DCP/NRC1000
NSD-NRC-97-5287
Docket No.: 52-003

SUBJECT: AP600 RESPONSE TO REQUEST FOR ADDITIONAL INFORMATION

RESPONSE REVISION 1

Question 720.387

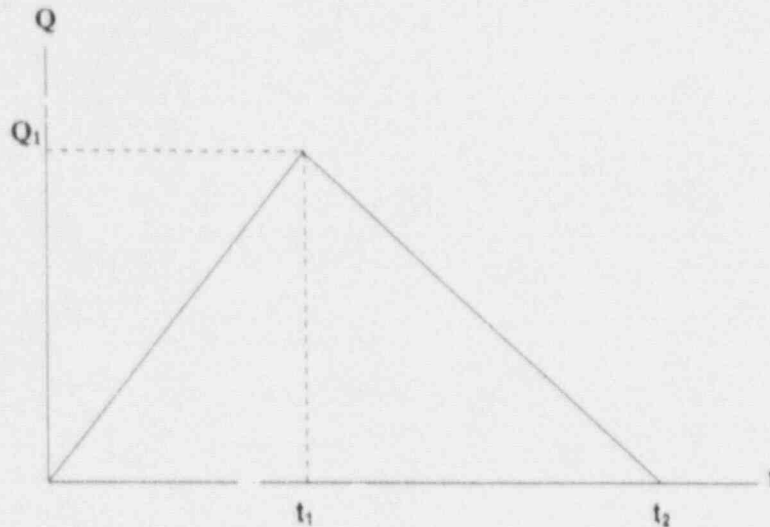
The deterministic evaluation of ex-vessel fuel coolant interactions (Appendix B to Revision 9 of the PRA) indicates that the impulse loads from ex-vessel steam explosions would fail the reactor cavity floor and wall structures, but that the embedded steel liner will stay intact. The evaluation also indicates that containment vessel integrity will not be compromised by the displacement of the RPV due to the impulse loading. Please submit additional details regarding the calculation of containment vessel strains referenced in Section B.3.2.1 and the calculation of maximum lift of the RPV referenced in Section B.3.2.2.

and the other terms are defined in the figure below:

The values assigned to the variables in the above equations are:

$$Q_1 = 607777 * K,$$

$$P = \text{max pressure} = 1.75E8 \text{ Pa or } 25725 \text{ psi}$$

$$\text{Force} = P * \text{Area} = 25725 (23625.9) = 607777 \text{ kips}$$

$$K = 0.0 \text{ to } 9539601 \text{ k/in.}, \text{ range of stiffness calculated based upon } F, \\ \text{where } K = (2 * p * F)^2 * W / 386.4$$

$$F = 0.001 \text{ to } 300 \text{ Hz}$$

$$W = 1037.445 \text{ kips (weight of RPV minus the weight of the internals)}$$

$$t_2 = 0.004 \text{ seconds}$$

$$t_1 = 0.002 \text{ seconds}$$

$$p = 1884.96 \text{ rad/sec circular frequency}$$

The controlling steam blast impulse loading is best approximated by a triangular pulse (shown above) having a duration of 0.004 seconds. The calculation of the maximum displacement of the reactor pressure vessel follows the same time history dynamic formulation as described for the triangular impulsive load until time t is greater than t_2 . The results at time t_2 are used to calculate the maximum displacement since this formulation does not account for gravity effects. The potential energy associated with mass M as it is lifted to its maximum height is equated to the difference between the kinetic energy defined using the maximum velocity (approximately at time t_2) and the strain energy of the piping. Shown in Figure 720.387-3 is a plot of the reactor pressure vessel (RPV) uplift obtained from this analysis as a function of system frequency. The system stiffness is defined by the reactor coolant piping. As the piping plastically deforms, the frequency decreases. A lower bound frequency of 1 hertz is considered. This results in an uplift of six feet. Even if the piping instantaneously failed, which is not expected, the uplift would still be around 22 feet. As seen in Figure 720.387-4, the reactor pressure vessel will not leave the refueling canal area.
